ITEM 5. DEVELOPMENT APPLICATION: 84-92 EPSOM ROAD ZETLAND**FILE NO: D/2014/1928****DEVELOPMENT APPLICATION NO: D/2014/1928****SUMMARY**

Proposal Summary: The staged construction of a mixed use development comprising 4 residential flat buildings between 2 and 11 storeys with 215 apartments and 620sqm of retail premises / commercial premises. Excavation of 1 level of basement parking with a total of 223 vehicle car parking spaces over basement and ground floor level. Landscaping, public domain and infrastructure works are also proposed. The application involves the construction of portion of Rose Valley Way and Fuse Street, subdivision of development lots and road dedication.

Figure 19 – Proposed Building A demonstrating breach of 35m height control

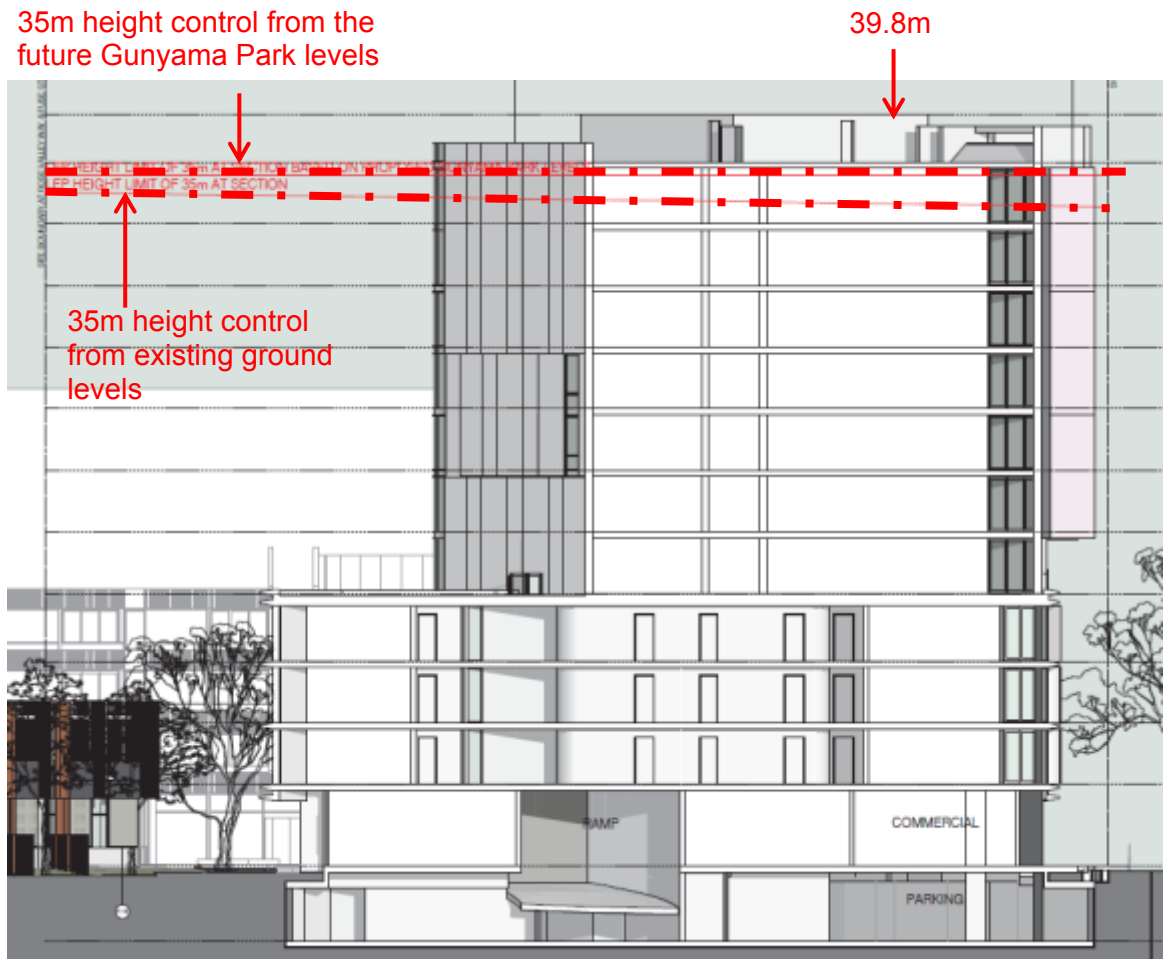
82. With respect to Building A, the proposal has a maximum height of approximately 39.8m to the top of the lift overrun and roof plant. The proposal is shown in Figure 19.

87. It is considered that the written statement provided by the applicant has sufficiently justified that strict numeric compliance with the development standard is unreasonable and unnecessary in this instance. The proposal largely meets the building height control within the Sydney LEP 2012 Amendment No. 13 and it is appropriate to give these controls significant weight in the assessment of this application.
88. For the reasons outlined above, there are sufficient planning grounds to justify the departure from the height development standard and it is recommended that a Clause 4.6 exception be granted.

Figure 20 – Proposed Building D demonstrating breach of 30m height control

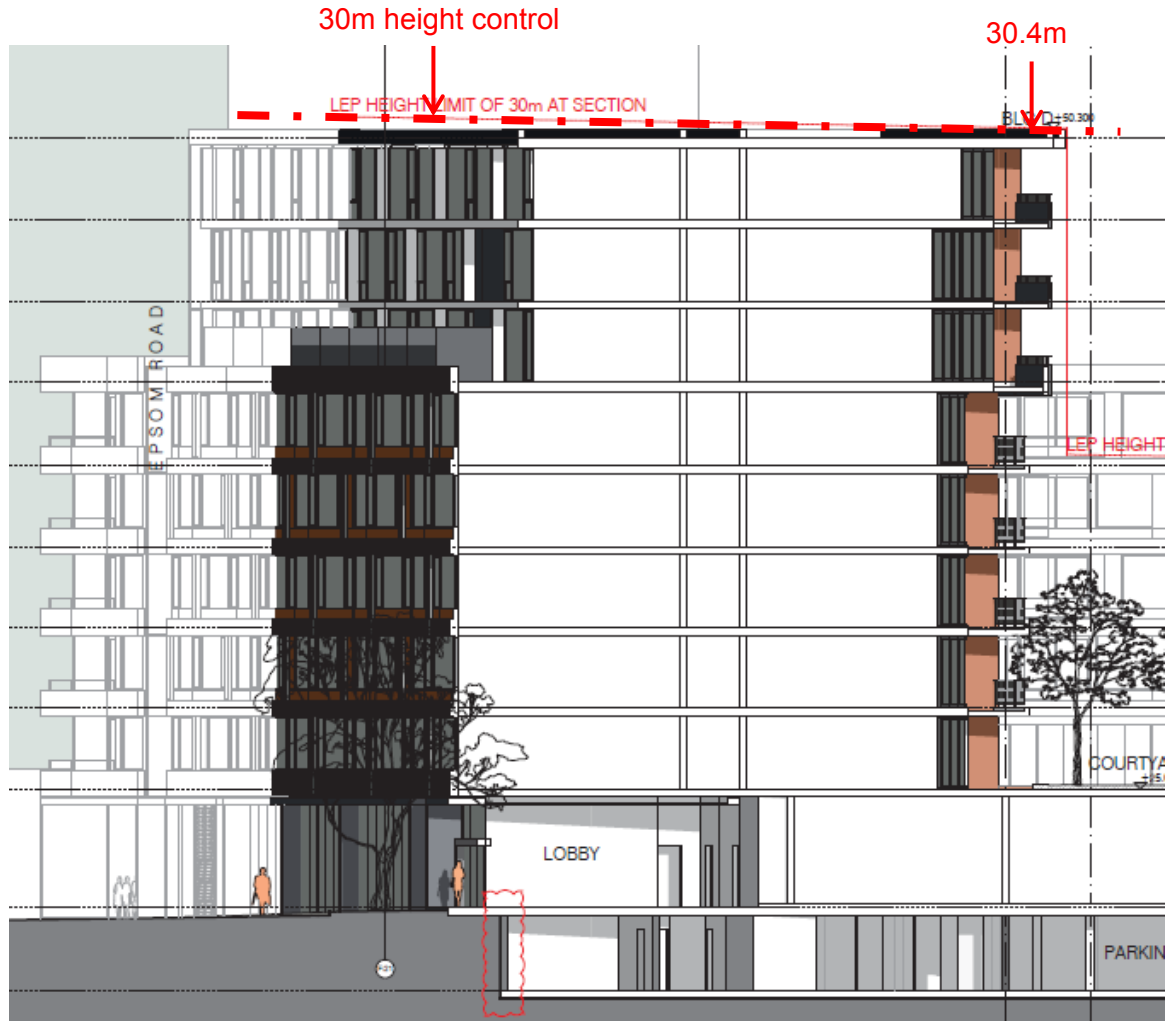
83. With respect to Building D, the proposal has a maximum height of approximately 30.4m. The proposal is shown in Figure 20.

Figure 22: Temporary Fuse Street Driveway at Stage 1 - to be in filled with unit G22 at Stage 2

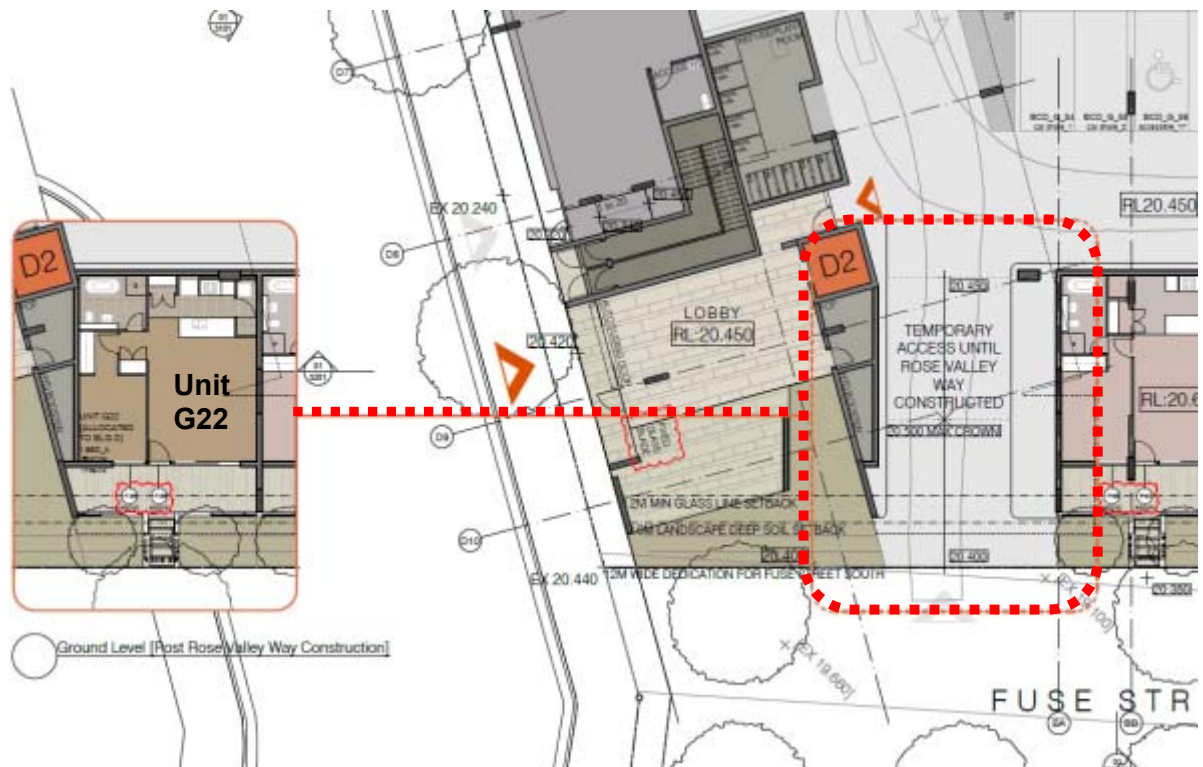
89. Stage 1 of the development involves the excavation of 1 level of basement parking under Buildings B, C and D for 131 spaces, plus a ground floor sleeved car parking area with 59 spaces (190 total). This parking area will have temporary vehicular access off Fuse Street as shown in **Figure 21**.
90. This temporary driveway on Fuse Street will be closed and the space filled in with a single level ground floor unit (G22) (shown in **Figure 22**) when Rose Valley Way is constructed as part of the Stage 2 works. A condition of consent requiring its completion prior to the issue of an occupation certificate for Building A is recommended. The new, permanent, entry will be located on Rose Valley Way, shown in **Figure 21**.

- (a) Prior to the issue of an Occupation Certificate for Stage 2 / Building A the temporary access drive-way on Fuse Street South must be removed with the Fuse Street footpath reinstated and made-good and the part of the building comprising Unit G22 constructed as shown on approved drawing DA-00-2100-G issue 12 prepared by Allen Jack & Cottier.
- (b) Prior to the issue of an Occupation Certificate for Stage 2 / Building A the temporary barrier to the car parking access to Building B, C and D (on Lot 121) on Rose Valley Way must be removed and the permanent access reinstated/opened to the carparking for those buildings as shown on approved drawing DA-00-2100-G issue 12 prepared by Allen Jack & Cottier.

Figure 25 – Building A ground floor interface with Gunyama Park

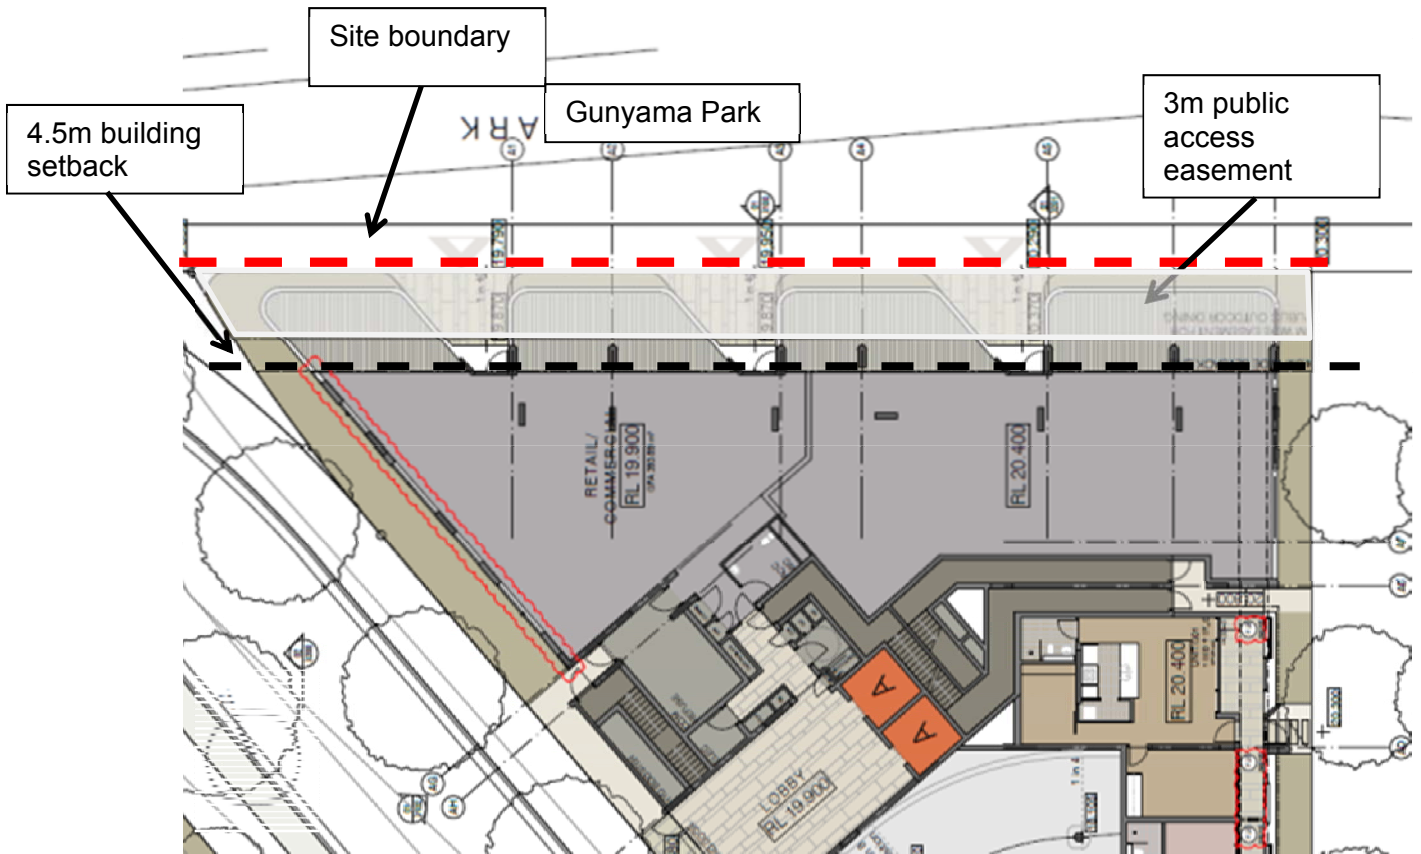
111. The Sydney DCP 2012 requires a 3m public easement for public access (outdoor dining) along the northern façade of Building A, at its interface with Gunyama Park. This easement is proposed and the area provides a series of ‘terrace’ areas, accessed from the commercial/retail space and bordered by planters as shown in **Figure 25**.

112. This arrangement has been reviewed by the City’s Public Domain unit as well as the City’s Design Managers involved in the delivery of Gunyama Park. They have noted that this proposal uses the setback space to rationalise the level changes between Gunyama Park and the floor levels of Building A and level public access is only possible from Gunyama Park. Given this easement for public access, the area should provide as level and contiguous space, without the raised terrace areas. Smaller raised terrace areas may be achievable in the 1.5m between the glass line and where the easement begins.

113. A deferred commencement condition is recommended that details that the terraces shown on the plans at the Gunyama Park/Building A interface are not approved. It will require the 3m easement area along the building frontage to be designed to allow a continuous path of travel along the facade and be aligned with the park boundary. The condition will require the design of the interface to be developed in consultation with the City’s Public Domain unit.
